GE Hitachi Nuclear Energy

Subject: Pre-application Presentation Slides for Amendment to NEDO-11209-A Revision 15,
GE Hitachi Nuclear Energy Quality Assurance Program Description”

1. GEH QAPD NEDO-11209 Revision 16, Pre-Application Meeting Presentation Slides
2. NEDO-11209-A, Revision 15 markup for Revision 16

GEH QAPD NEDO-11209 Revision 16, Pre-Application Meeting Slides

FIGURE 1: ORGANIZATIONAL STRUCTURE

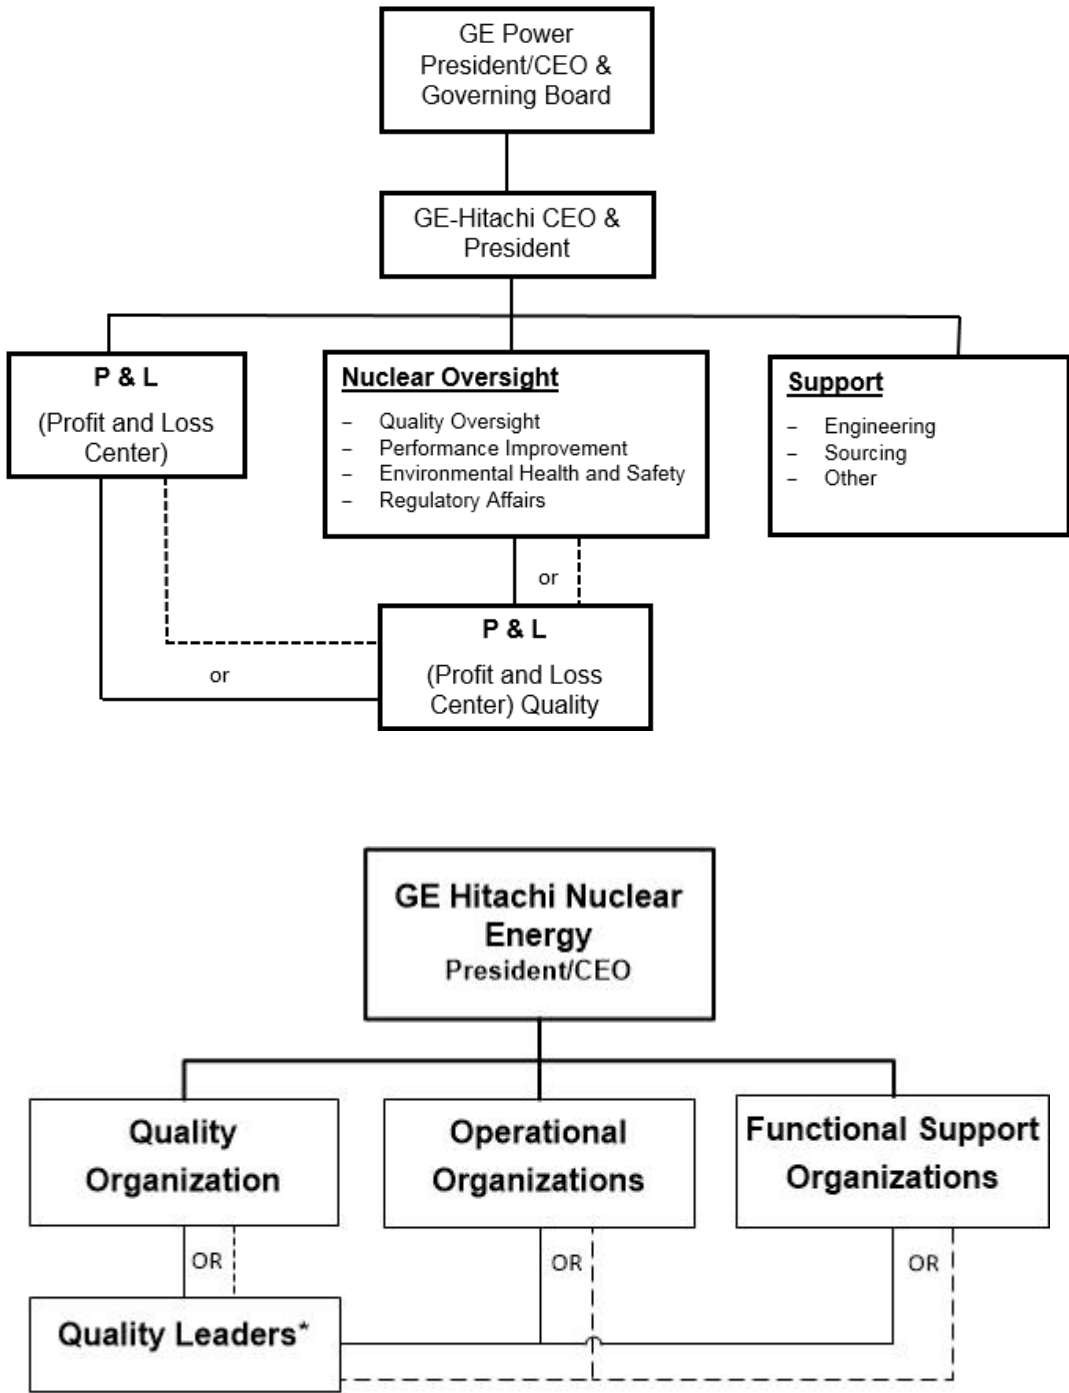
<u>11</u>	Acronyms and Abbreviations	Added definitions for NOS and NPP; moved US NRC for alphabetical order.		
	PART I INTRODUCTION				
	12	1.0 Scope/Applicability	Reuter Stokes to Reuter Stokes LLC		
	13	1.0 Scope/Applicability	GS-R-3 to GSR Part 2		
	13	1.0 Scope/Applicability	Added "LLC" after "Reuter Stokes"		
	PART II QAPD DETAILS				
	15	1.3.1 Profit and Loss Organizations	At end of first sentence, deleted "including Nuclear Fuels & Services and Nuclear Plant Projects."		
	15	1.3.1 Profit and Loss Organizations	Moved content previously in Sections 1.3.1.1, 1.3.1.2 and 1.4.3 and modified it to reflect current organization structure and responsibilities.		
	15	1.3.1.1 Nuclear Fuels & Services	Section 1.3.1.1 has been deleted, its content is included in paragraph 1.3.1		
	15	1.3.1.2 Nuclear Plant Projects	Section 1.3.1.2 has been deleted, its content is included in paragraph 1.3.1		
	16	1.3.2 Support Organizations	Updated this section to reflect new organization as shown on revised Figure 1

- 1.3.1 For the purposes of managing the GEH ~~QMS Quality Management System~~, the organizational structure is shown in Figure 1.
